I.1 INTRODUCTION AND SUMMARY

In accordance with these requirements, the Final Mount Signal and Calexico Solar Farm Projects EIR is comprised of the following:

- Draft Environmental Impact Report, Mount Signal and Calexico Solar Farm Projects (November 2011) (SCH No. 2011071066); and
- This Final EIR document, dated March 2012, that incorporates the information required by §15132.

II.1 CORRECTIONS AND ADDITIONS

Modified CSF2(A) Site Plan Incorporating 125-Buffer from Private Airstrip
FIGURE I-1

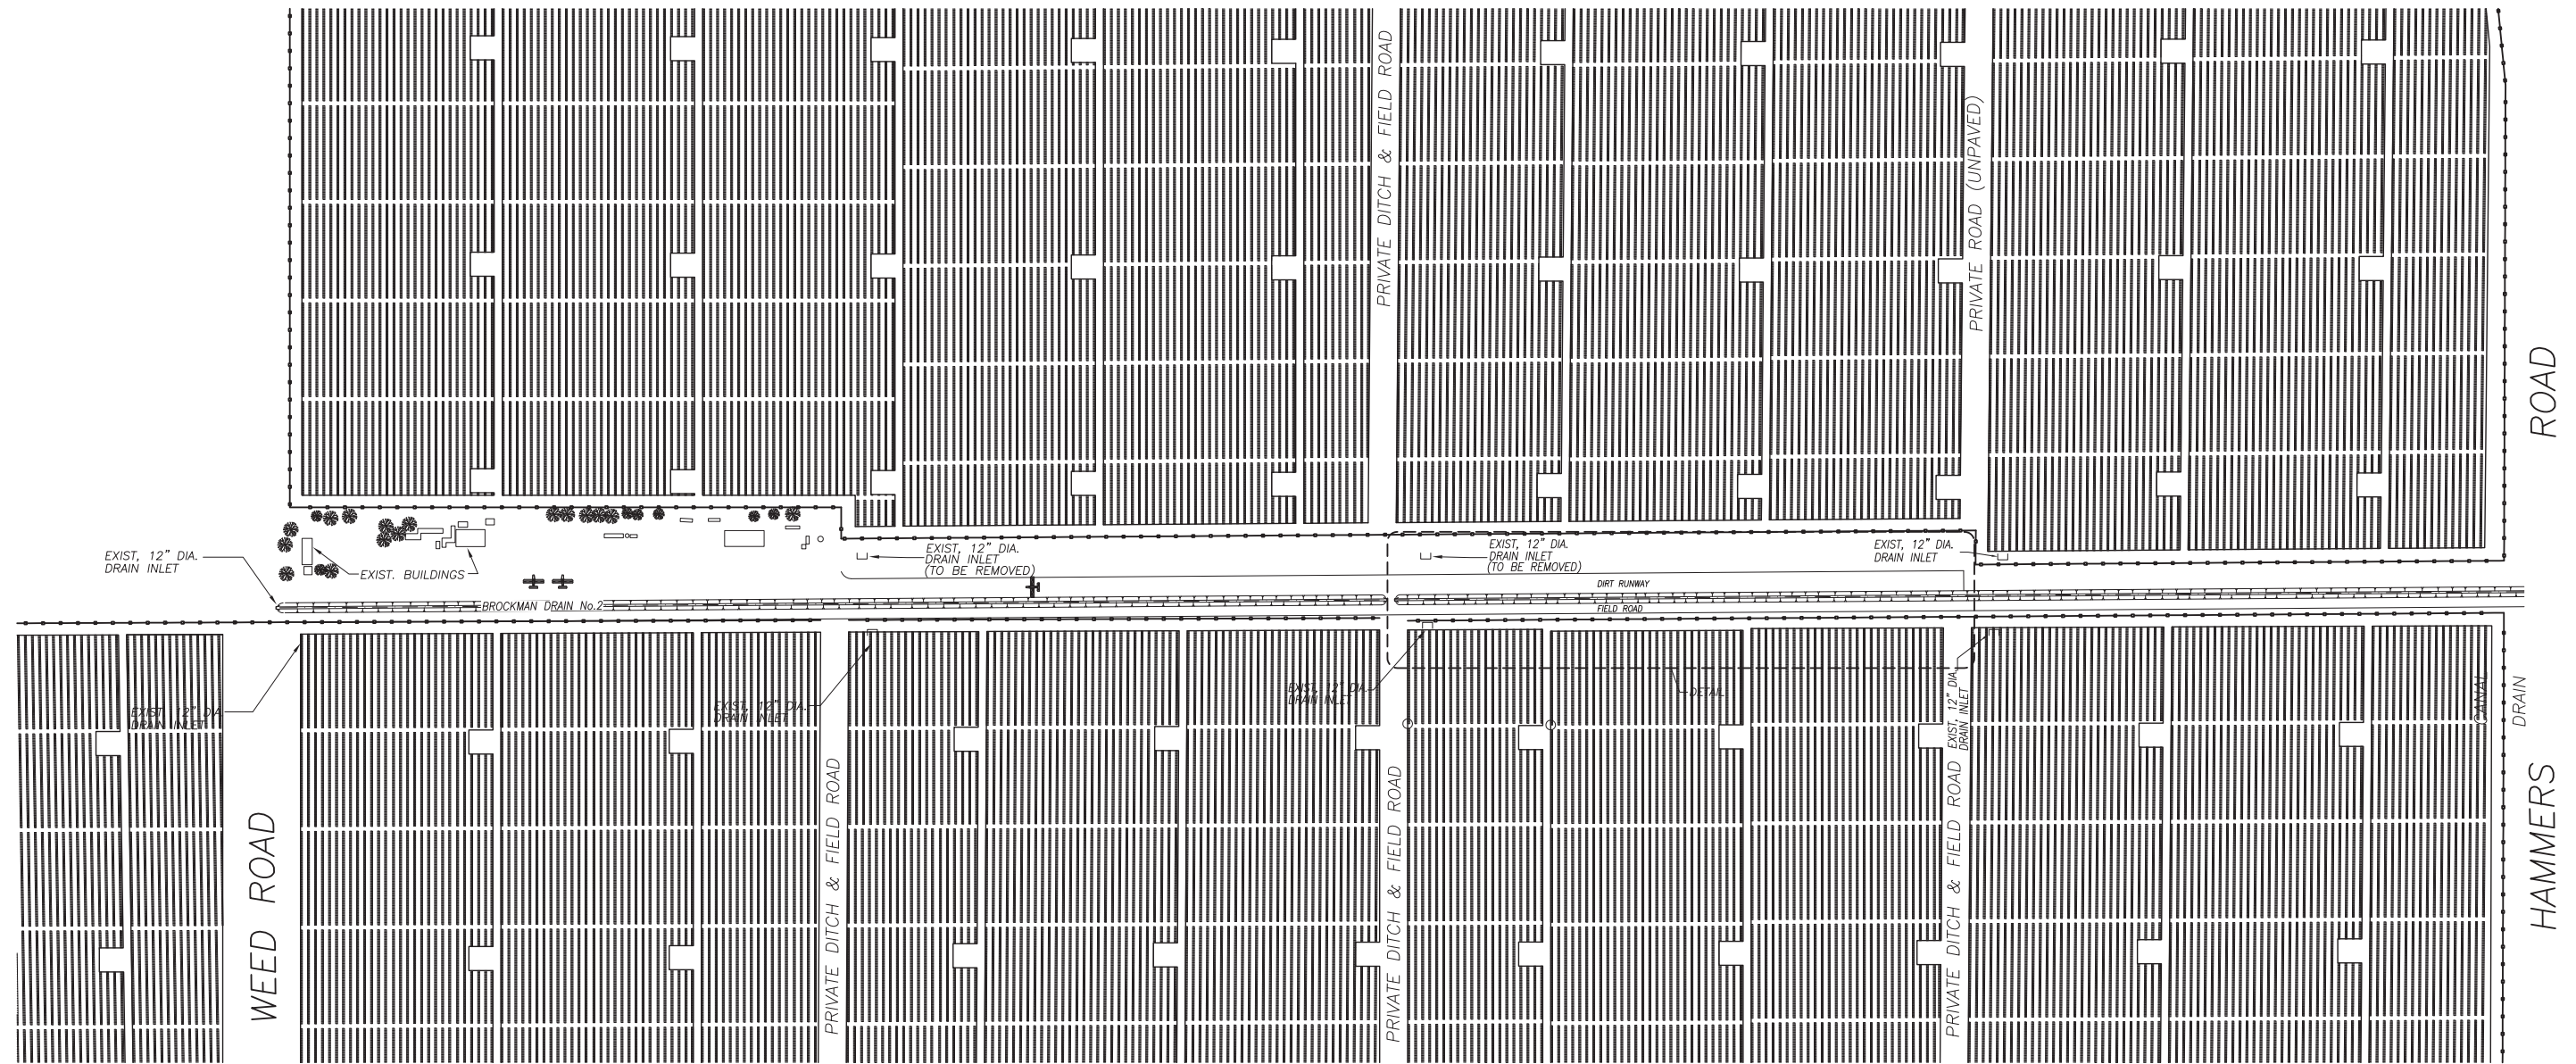
Final EIR Section	Description of Revisions
	<ul style="list-style-type: none"> • Figure I-1, which is added to the end of this section, provides an updated site plan for CSF2(A). This figure, titled “Modified CSF2(A) Site Plan Incorporating 125-Buffer from centerline of Private Airstrip” revises a portion of the CSF2(A) site layout shown in EIR Figure 3.0-11. • Section 3.2: The first project objectives was modified to clarify that producing up to 600 MW of renewable electricity would help meet the State-mandated RPS of 33% renewable energy by 2020. Three additional project objectives were added including: <ul style="list-style-type: none"> - Construct a facility at a location near the U.S. border to avoid issues of leapfrog development and dividing up stretches of agricultural land. - Sustain and stimulate the economy of Southern California by helping to ensure an adequate supply of renewable electrical energy while simultaneously creating additional construction and operations employment and increased expenditures in many local businesses. - Contribute to Imperial County’s economic growth and reputation as the renewable energy capital of the nation. • Section 3.3.7: Modified to clarify that a small Point of Entry Water Treatment System may be required for the O&M Buildings. • Section 3.5: Revised to clarify that a restoration plan would be required for each project site. • Section 3.6.1: Modifications to list of required approval to clarify that a Restoration Plan will be required for each project and that the County will conform financial assurances for the projects are in conformance with Imperial County ordinances. Also, Williamson Act Contract Cancellation has been added to the list of required approvals and the requirement for a Development Agreement has been removed. • Section 3.6.2: Added BLM ROW grant application for the off-site transmission facility (OTF) to list of approvals by other agencies.

Final EIR Section	Description of Revisions
	<ul style="list-style-type: none"> • Section 4.8.2.3: Clarified potential impacts to aircraft operations. • Section 4.8.2.3: Expanded discussion of potential impact to Johnson Brothers private airstrip and added additional reflectivity analysis to technical appendix and discussion of the revised site plan for CSF2(A) that incorporates the 125-foot buffer from the centerline of the airstrip. • Section 4.8.3: Added a discussion of decommissioning/restoration.
